Artist scale impression of Rampion 2 viewed from Littlehampton pier

**Written Representation from Carlo Marogna
representing the Constructive Heritage partnership**

SUMMARY:

Figure 8.20
 Predicted worst-case behavioural response impact ranges of herring from the sequential piling of monopile foundations. Rampion 2 Environmental Statement

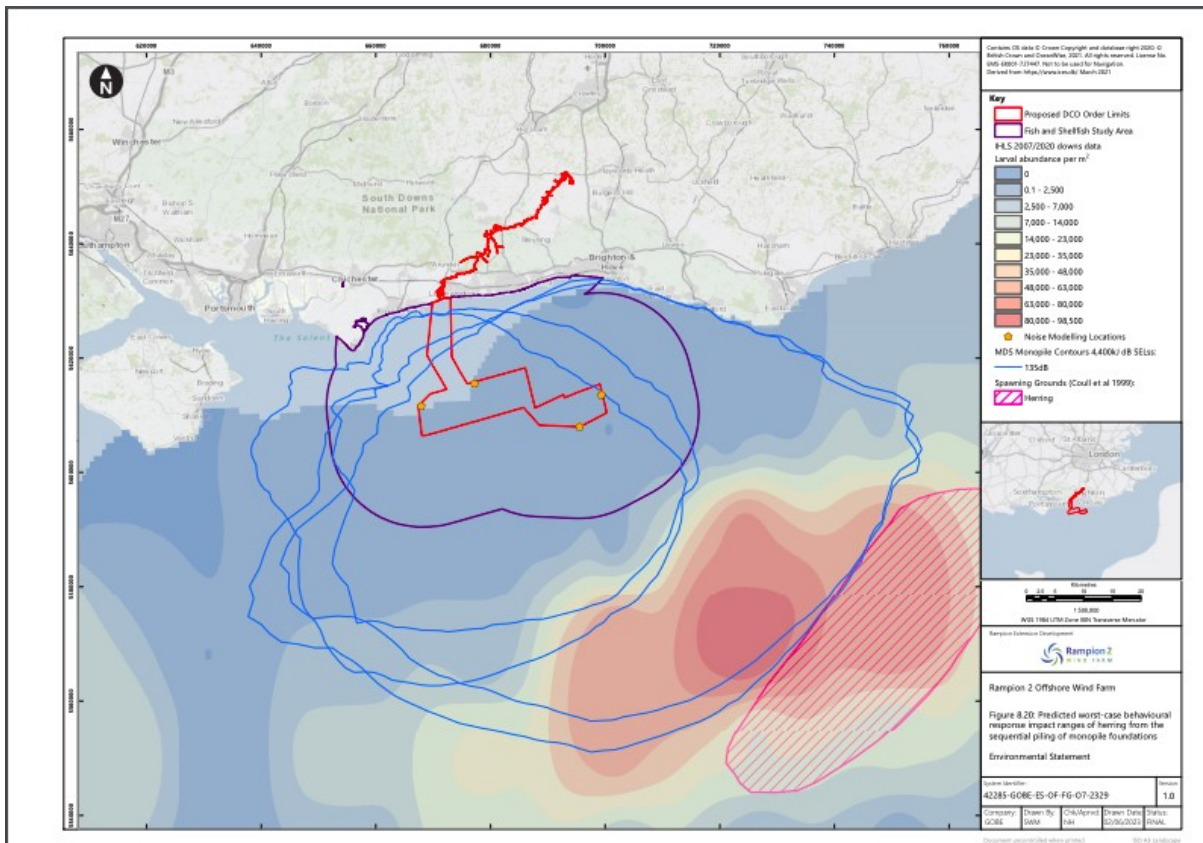
Figure 8.20 presents the SELss contours for sequential mono-piling in the four modelling locations of Rampion Array, with noise contours presented based on the unweighted SELSS 135dB as per Hawkins et al. (2014). This is appropriate, and Figure 8.20 indicates significant overlap with the Downs herring spawning ground, as indicated by IHLs larval abundance data.”⁸

[The modelling evidences high sound pressure levels travelling across dozens of miles with little attenuation. This is likely to cause severe disturbance.]

Figure 8.19
 Predicted worst case impact ranges for stationary receptors from the sequential piling of monopile foundations. Rampion 2 Environmental Statement

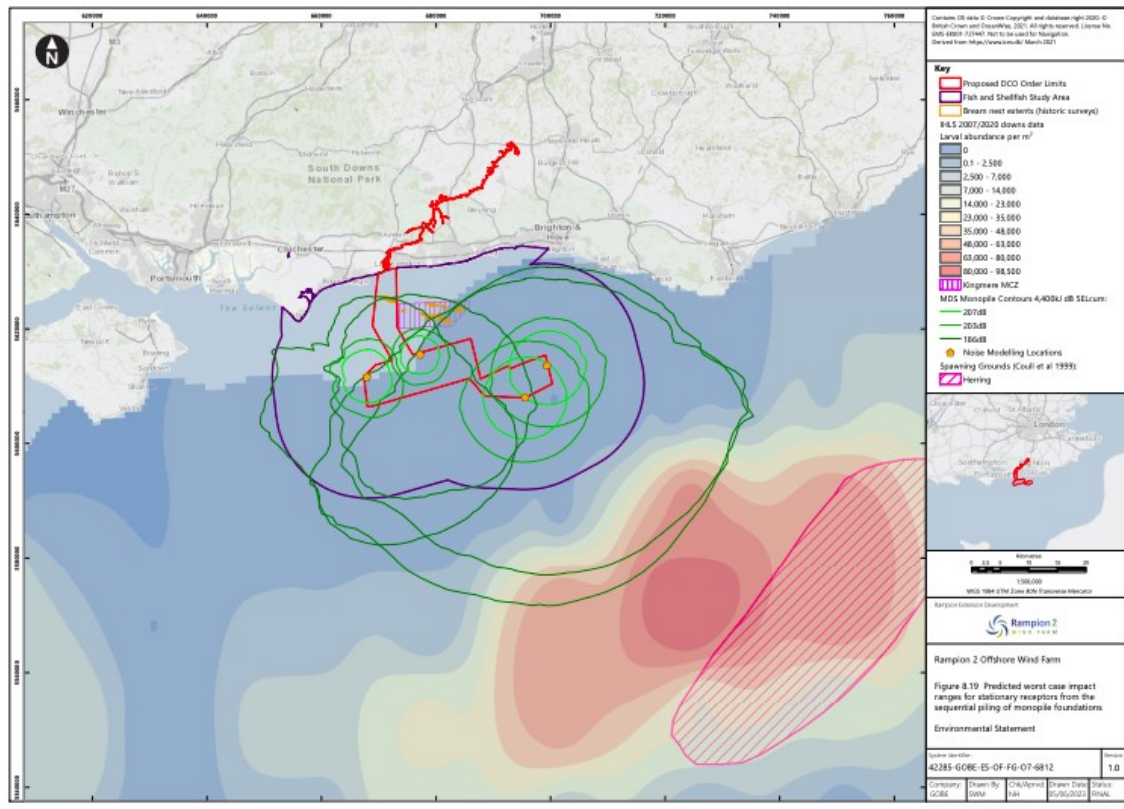
The Sound Exposure levels cumulative or otherwise, are likely to be much higher than these.
